Service Bulletin

Subject	Change from the first mass production
Model	TASKalfa5550ci, TASKalfa4550ci, TASKalfa3550ci, TASKalfa3050ci

Since the first mass production, the following parts have been changed/added/deleted. And, the parts name of the fuser unit is changed from "FK-100/200" to "FK-8506/8507" since the 1st shipment. Please refer to page 4 for the change of the parts name.

<Content of changes>

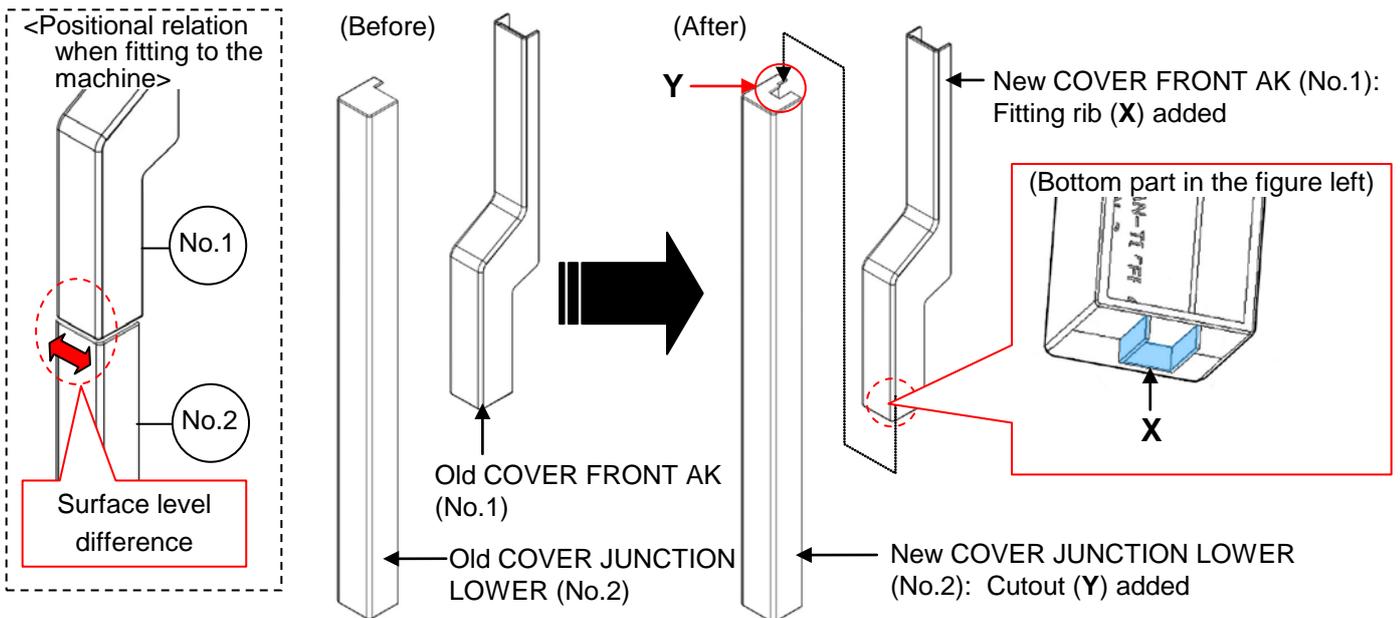
The shapes for fitting (X, Y in the figure below) are added to COVER FRONT AK (No.1) and COVER JUNCTION LOWER (No.2)
